Lotus Elan M100 Service Bulletins
Series 1 and Series 2 1990 - 1996

SERVICE BULLETIN

TITLE: Replacement of headlamp flap 'J' links.

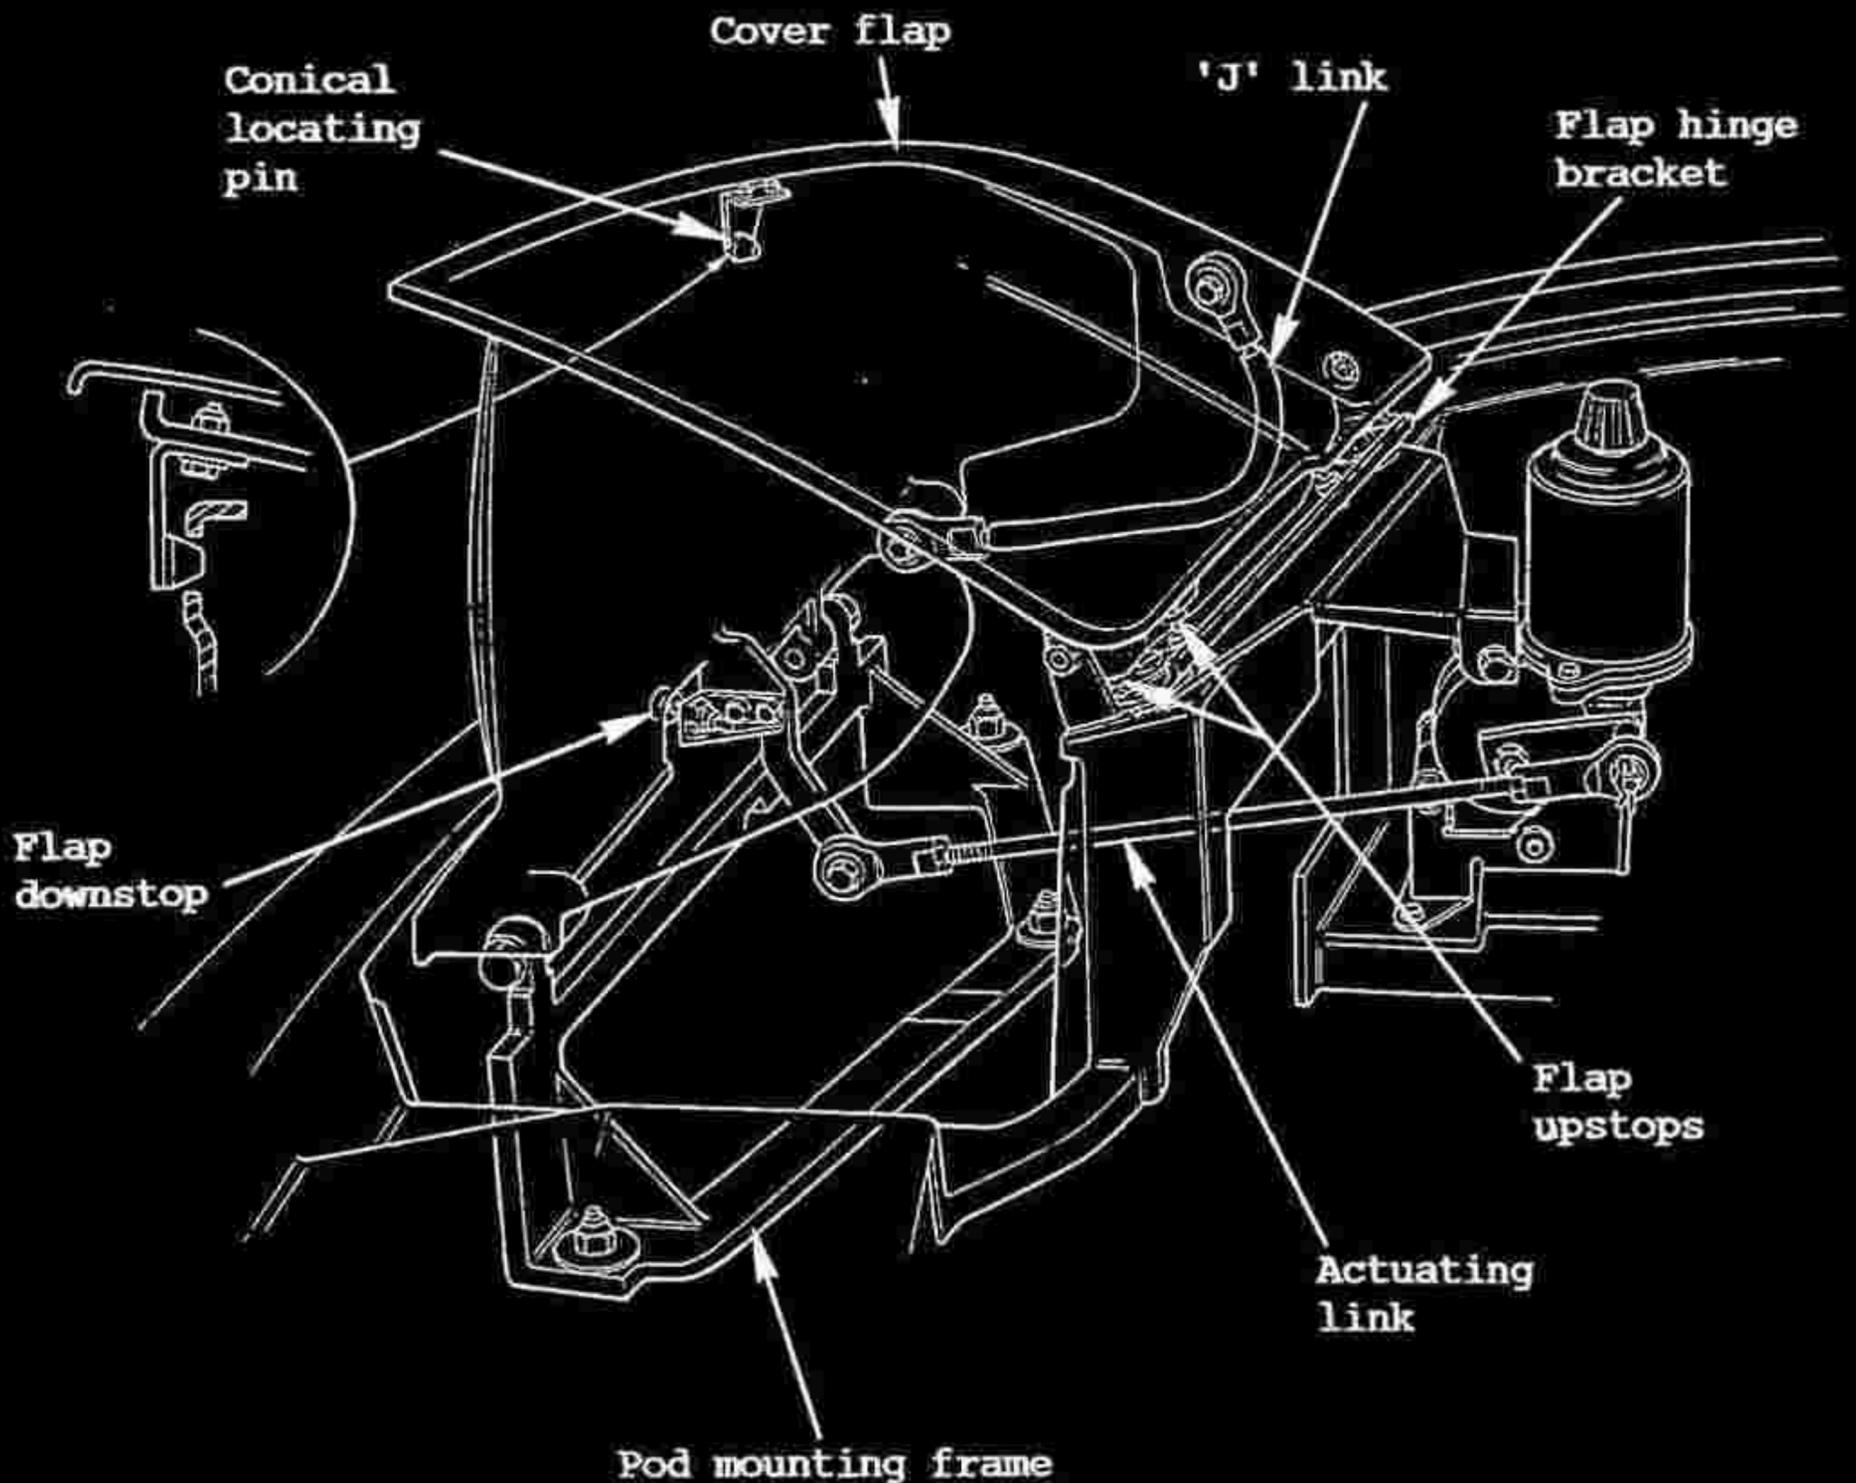
REASON: Incorrect material specification of some links may result in distortion of link and faulty operation of headlamp mechanism.

(Note that correct links are identified by a white band)

Before fitting the 'J' links, ensure that each link is correctly identified and adjusted as shown in the diagram.

View of steering rack
with underframe
removed

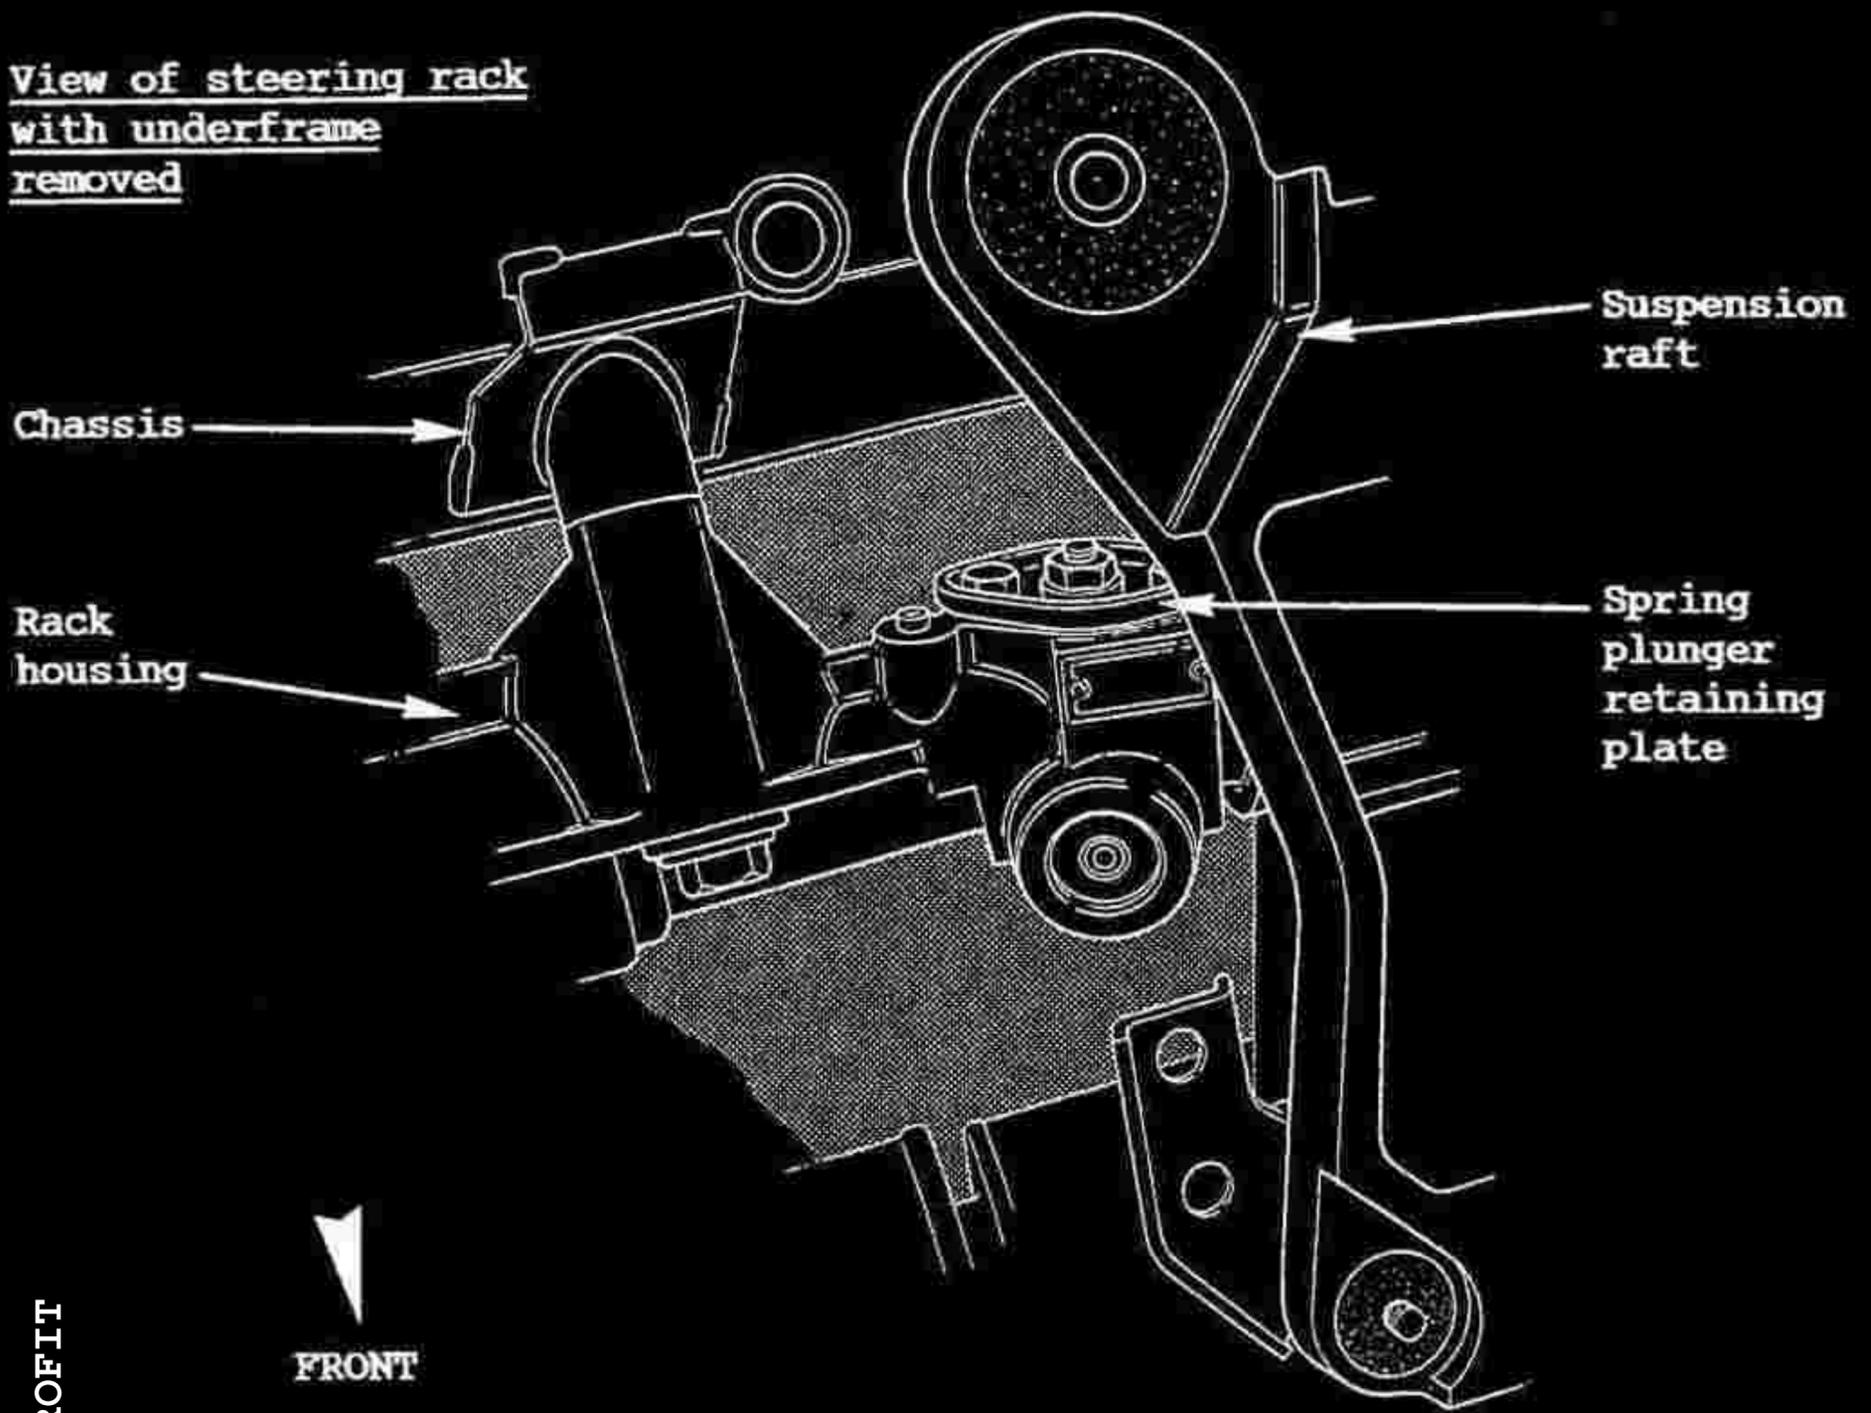
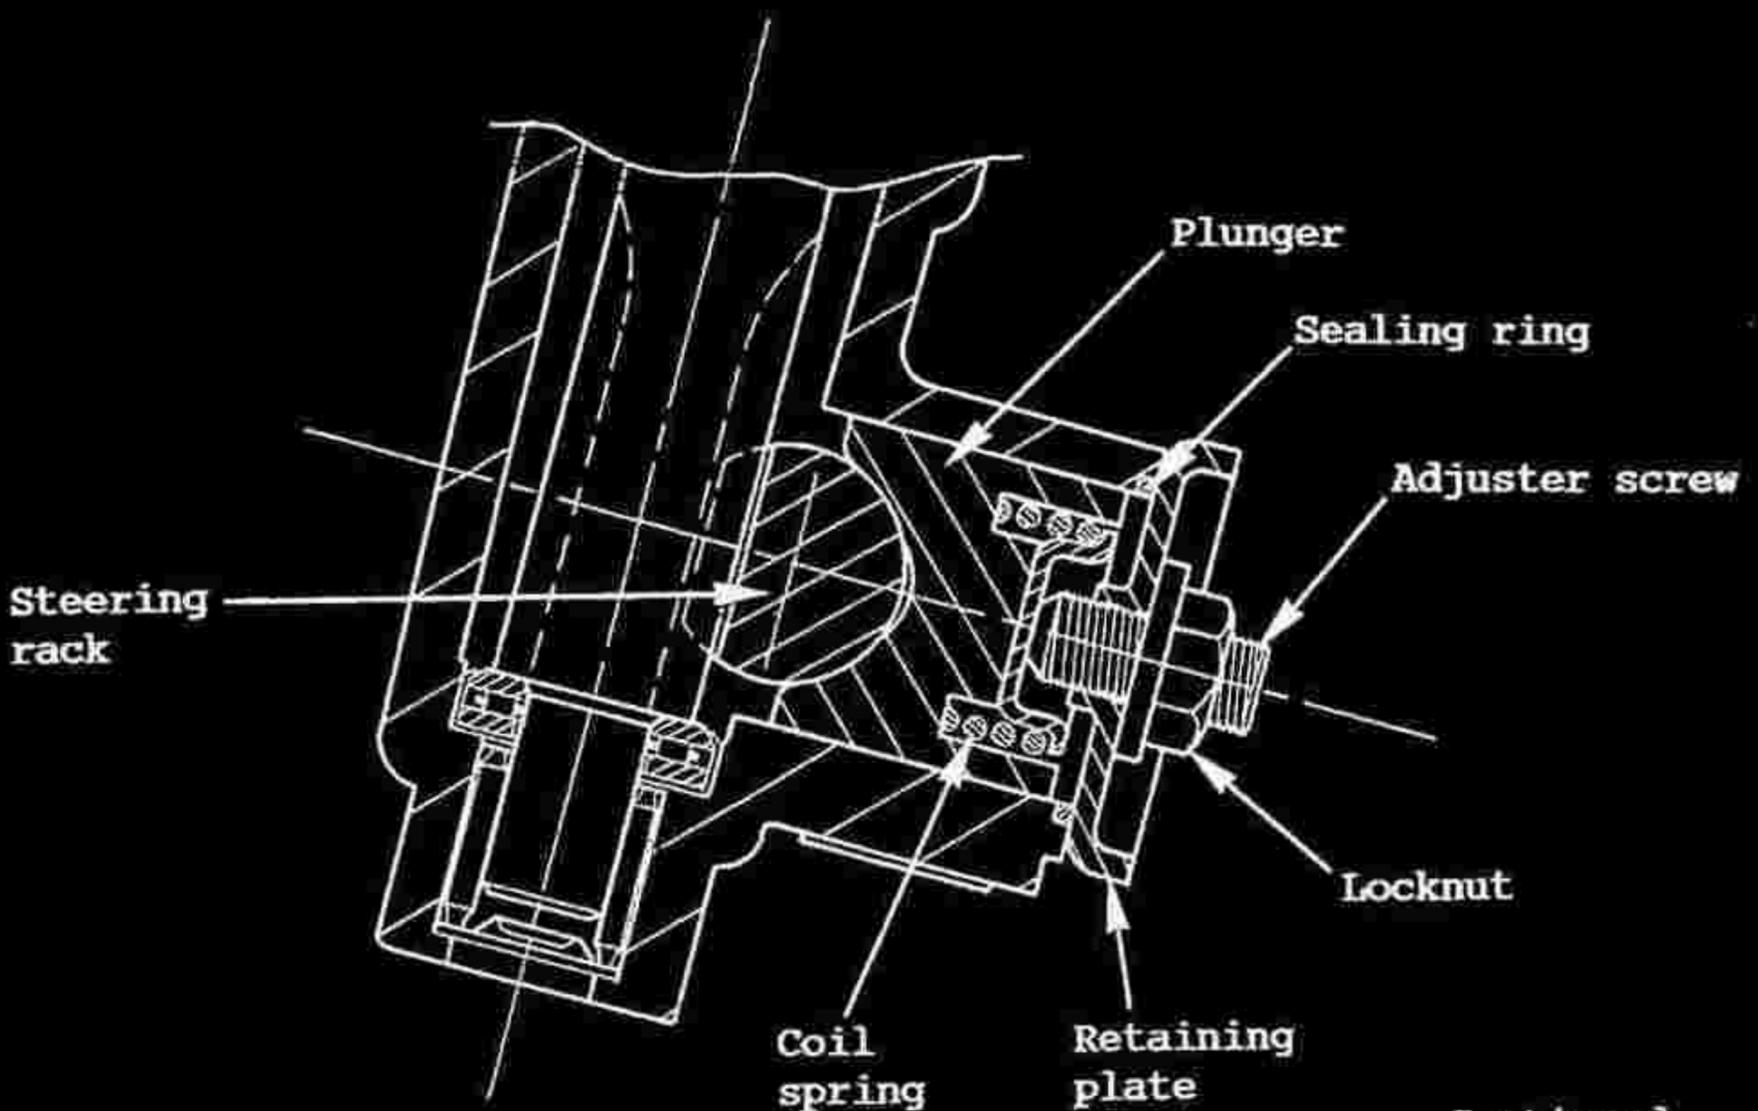
ACTION: At the next opportunity, (i.e. next time the vehicle is on the dealer premises) replace the steering rack plunger on all 1990 model year Elan and Elan S.E. models, manual and PAS, in the following VIN range:

- Withdraw the underframe.
3. At the rear of the steering rack pinion housing, slacken the plunger adjuster screw locknut, and back off the adjuster screw to relieve some of the plunger spring pressure. Release the two screws securing the retaining plate (NOTE: Plate is spring loaded), and remove the plate, spring cup and spring.

5. Refit the spring and spring cup, and check that the sealing ring is correctly positioned on the rack housing before fitting the retaining plate with its two screws and shakeproof washers. Torque tighten the two fixings to 23 Nm (17 lbf.ft).

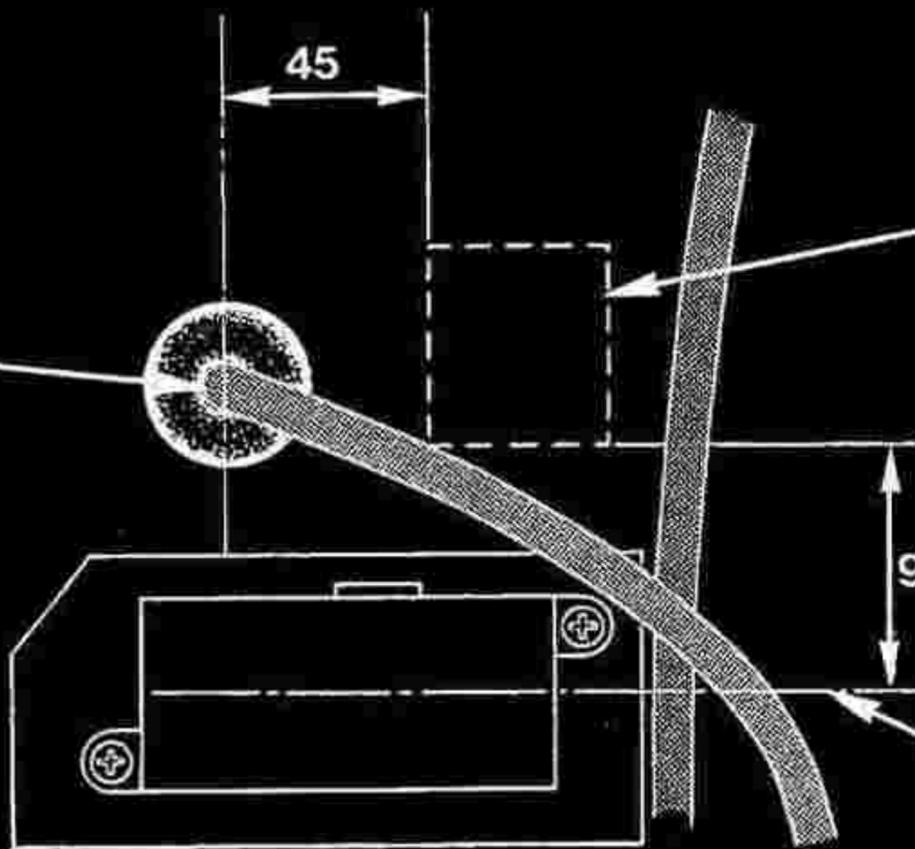
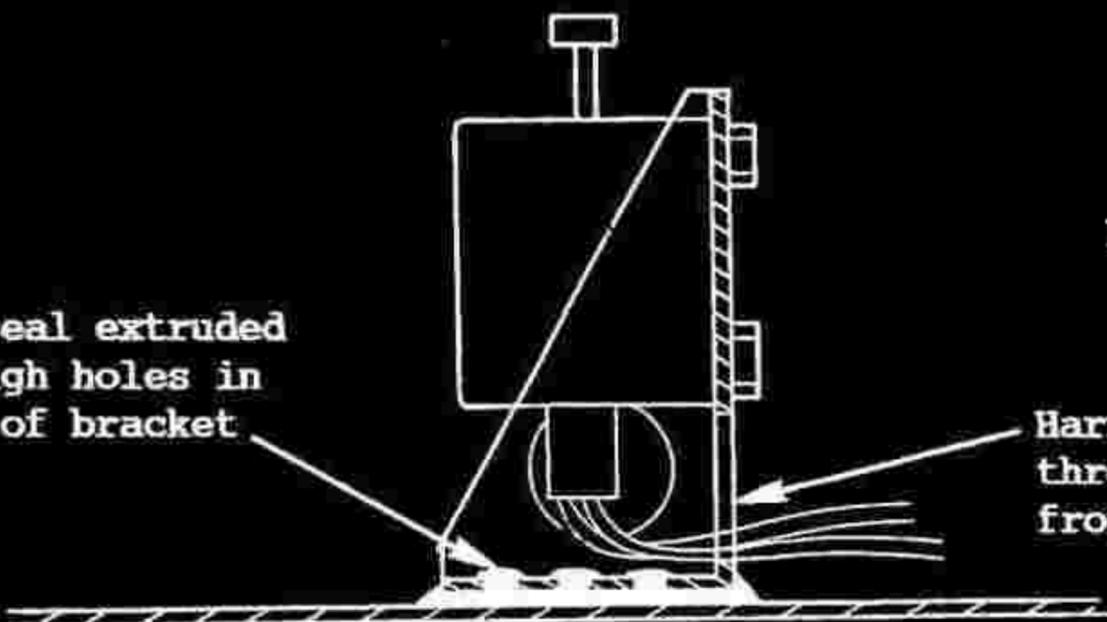
On request to the Warranty Dept., quoting the VIN, an inertia switch mounting bracket will be supplied free issue.

4. Thoroughly clean the area shown in the diagram where the new mounting bracket is to be bonded. Use the contents of Betaseal kit A075B6158J (used for windscreen fitment on all models) to wipe the bonding areas on both body and bracket with Betawipe.

Betaseal extruded through holes in base of bracket

Harness routed through hole in front face of bracket
